Device **XC866L-4FR**
Marking/Step **BC**
Package **PG-TSSOP-38**

This Errata Sheet describes the deviations from the current user documentation. The module oriented classification and numbering system uses an ascending sequence over several derivatives, including already solved deviations. So gaps inside this enumeration can occur.

XC866 User's Manual	V1.2	June 2006
XC866 Data Sheet	V1.0	Feb 2006

Figure 1 Critical Cases for Power up/ Power down when $V_{residual} > 500mV$

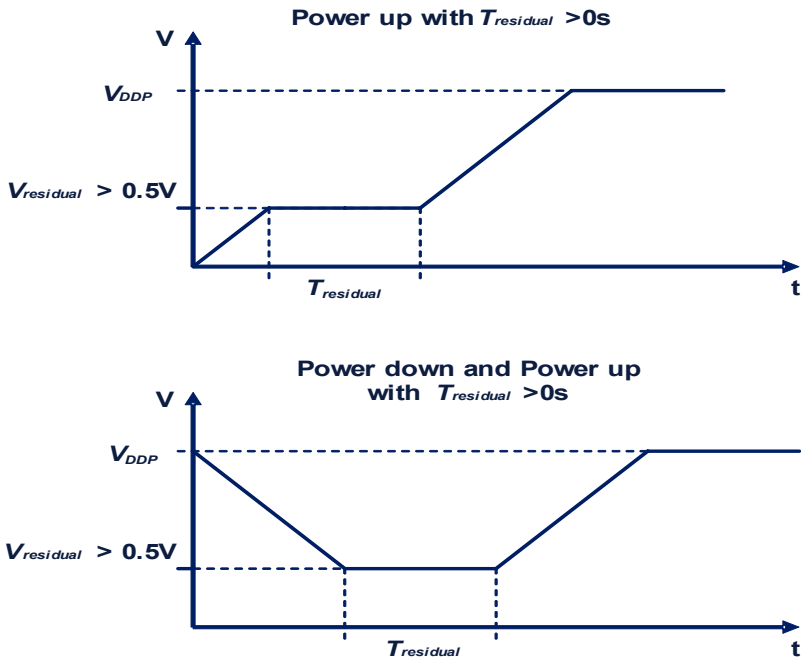
Due to the limitation of the EVR, the reset toggling may occur during the power up. To prevent the reset toggling issue for power up, the following conditions must be met :

1. For power up, the rising time must be less than $2\text{ms}/V$.
2. The power down time must be more than $0.2\text{ms}/V$.
3. A permanent V_{DDP} residual voltage is less than 500mV.

In case of V_{DDP} residual voltage is more than 500mV, the holding time of residual voltage affects the reset toggling issue. **Figure 1** shows the critical cases for power up/power down when the residual voltages is held for some time. **Figure 2** shows the uncritical case for power up and power down when the power up is triggered immediately after power down. In case of a residual voltage due to immediate power up after power down, the users have to contact IFX to ensure no power up failure.

INT_XC8.003 Unintended External Interrupt 0/1 Request in Bypass Edge Detection Mode

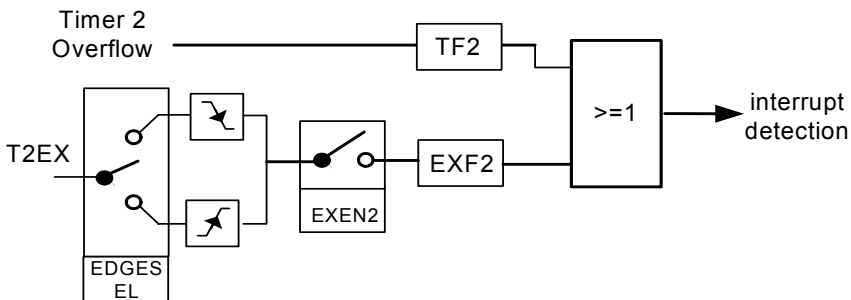
For external interrupt 0 or 1 in bypass edge detection mode with falling edge as the active event, clearing the IRCON0.EXINT0/1 flag while the pin input is still low will lead to the internal circuitry falsely detecting a falling edge event. This will lead to unintended interrupt request.

Never clear the IRCON0.EXINT0/1 flag in bypass edge detection mode. Access the TCON.IE0/1 flag directly instead, if necessary (TCON.IE0/1 flag is cleared automatically by hardware on vectoring to the interrupt routine).

Figure 4

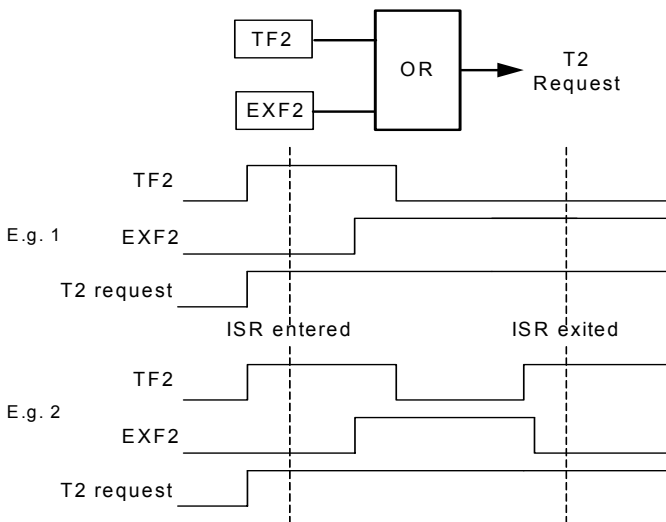
The problem is that it may occur at some point in the application, that any new Timer 2 interrupt request can no longer be detected after a return-from-interrupt (reti) due to service of earlier event(s). This happens when the following conditions are true:

1. Timer 2 events are serviced by interrupt (i.e. flags are checked and cleared only in the interrupt routine ISR),
2. Either TF2 or EXF2 is set at any one time throughout the ISR (even while the other is cleared) such that at least one of the flags is still set after reti, causing the Timer 2 request line, which is an OR-function of the two flags TF2 and EXF2, to remain set throughout the ISR and after reti.

This means, any future Timer 2 TF2 or EXF2 event is not able to cause a rising edge and therefore not able to trigger an interrupt request to the core – as if the Timer 2 interrupts had been disabled, until both EXF2 and TF2 flags are cleared at some time. The clearing of flags would have to be done by user’s code additionally outside of the Timer 2 interrupt routine, which is however normally not feasible with an interrupt service scheme.

There is no problem if EXF2 is not enabled by setting bit EXEN2 = 0 i.e. external events are disabled, or if bit DCEN = 1 in auto-reload mode.

Otherwise if EXF2 is enabled, while TF2 is always enabled when Timer 2 is running, there are two suggested workaround:

1. If other events of Timer 2 interrupt node (ET2) need not be enabled for interrupt, disable this interrupt node and use software polling of the flags instead.
2. Before return from interrupt, check again if TF2 or EXF2 is (still) set (due to new request since the last check). If so, jump and execute the ISR routine from start. Exit only when all flags are checked to be cleared. However, dummy interrupt of the node may occur after return from interrupt, and should be ignored. Another drawback is if Timer 2 events are occurring at high rate, the CPU may be 'stuck' in the service routine of the Timer 2 interrupt for a long time.

Figure 6

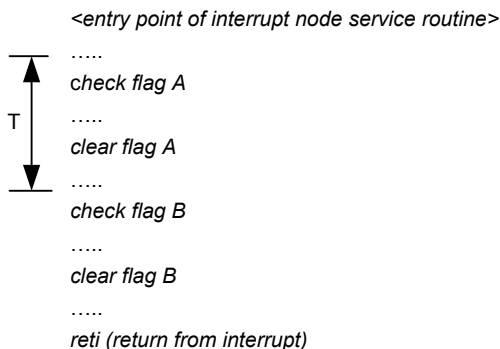
Consider the following interrupt service routine pseudo-code, and scenario where a interrupt source A event leads to interrupt request of the node and CPU vectors to the interrupt routine. Meanwhile, interrupt source B and its flag becomes active any time in the duration indicated by T:

In this case, flag B will be cleared as a standard procedure by the interrupt routine in the current service of the interrupt node. However, the pending

interrupt request for the node remains activated after RETI, as it is only cleared by hardware when CPU acknowledge the interrupt and vectors to the interrupt routine.

This leads to following servicing of the interrupt node again, but potentially no active flag is found, i.e. dummy interrupt service. The point to note is that the interrupt source B is not lost, as it was actually serviced in the current service of the interrupt node.

The recommendation is to ignore these dummy interrupt vectoring.
